SUMMER WOODS SUBDIVISION, PHASE THREE

AMENDED

APPLICATION NUMBER 10 DATE April 21, 2011

DETAIL SITE PLAN

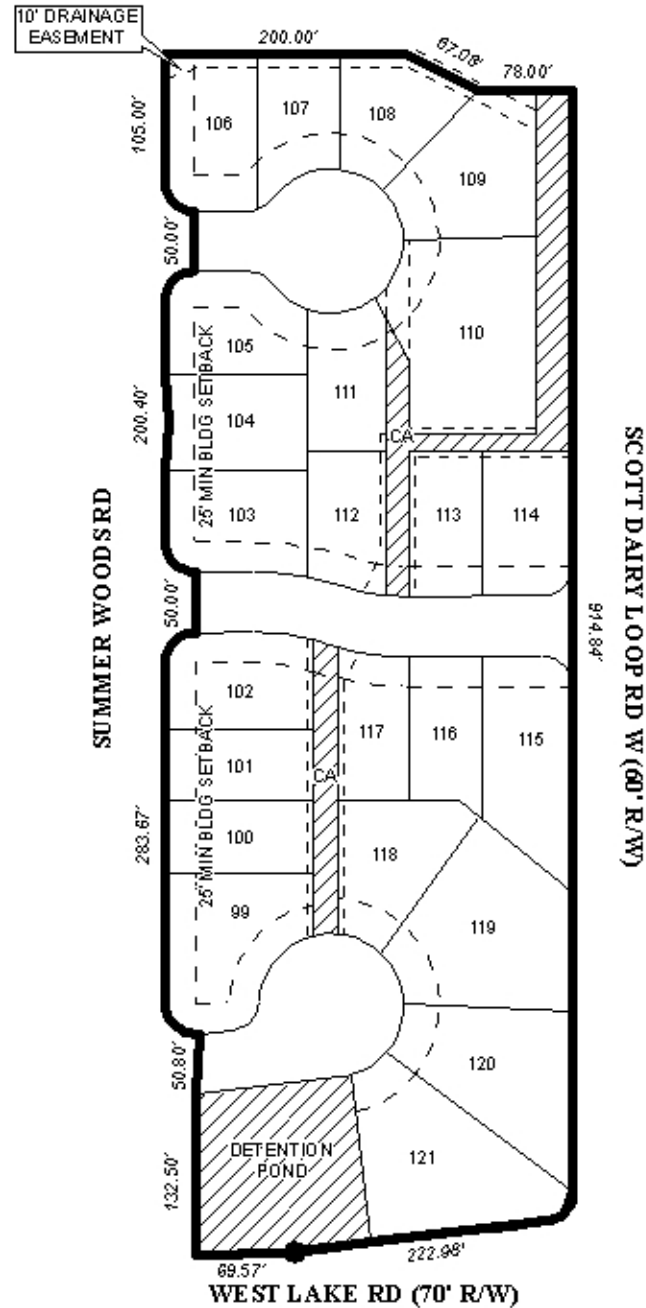
As a means of access management for several double-frontage lots, a note is placed on the preliminary plat stating that Lot 121 is denied direct access to West Lake Road, and Lots 109, 110, 114, 115, 119, 120, and 121 are denied access to Scott Dairy Loop Road West. Additionally, there is a note on the preliminary plat limiting each lot to one curb cut, with the size, location and design to be approved by County Engineering and conform to AASHTO standards. These notes should also be placed on the Final Plat, if approved.

The plat indicates a varying building setback line of 25' to 30' along all interior street frontages and this should also be indicated on the Final Plat. In the areas along West Lake Road and Scott Dairy Loop Road West where the drainage easement is proposed to be removed, a 25' minimum building setback line should be illustrated.

A table with the lot sizes is shown on the plat, and this should be retained on the Final Plat, if approved, or the lots should be labeled individually with their lot sizes. All lots meet the minimum size and frontage requirements of the Subdivision Regulations.

The plat indicates the presence of a small wetlands area where proposed Lots 109 and 110 are indicated, and meandering along the area of the proposed central drainage easement to the detention pond in the Southwest corner of the subdivision. Because of the wetlands presence, a note should be placed on the Final Plat, if approved, stating that approval of all applicable Federal, state and local agencies is required for endangered, threatened or otherwise protected species, if any, prior to the issuance of any permits or land disturbance activities.

The site is located in the County. As on the preliminary plat, a note should be placed on the Final Plat, if approved, stating that any lots which are developed commercially and adjoin residentially developed property must provide a buffer, in compliance with Section V.A.8. of the Subdivision Regulations. This note should be revised to read Section V.A.8. instead of Section V.A.7. as on the preliminary plat.

- 1) dedication and construction of the streets to County standards;
- 2) retention of a note on the Final Plat stating that Lot 121 is denied direct access to West Lake Road, and Lots 109, 110, 114, 115, 119, 120, and 121 are denied direct access to Scott Dairy Loop Road West;

- 3) retention of a note on the Final Plat stating that each lot is limited to one curb cut, with the size, location and design to be approved by County Engineering and conform to AASHTO standards;

- 4) retention of the minimum building setback line along all interior street frontages and revision of the plat to illustrate a 25' minimum building setback line where the drainage easement along West Lake Road and Scott Dairy Loop Road West is removed;

- 5) retention of the table illustrating lot sizes on the plat or provision of the same information on the individual lots;
- 6) placement of a note on the Final Plat stating that approval of all applicable Federal, state and local agencies is required for endangered, threatened or otherwise protected species, if any, prior to the issuance of any permits or land disturbance activities;

- 7) placement of a note on the Final Plat stating that no construction is allowed within any easement;
- 8) placement of a note on the Final Plat stating that the maintenance of all common areas is the responsibility of the property owners and not Mobile County;

- 11) placement of a note on the Final Plat stating that any lots which are developed commercially and adjoin residentially developed property must provide a buffer, in compliance with Section V.A.8. of the Subdivision Regulations.
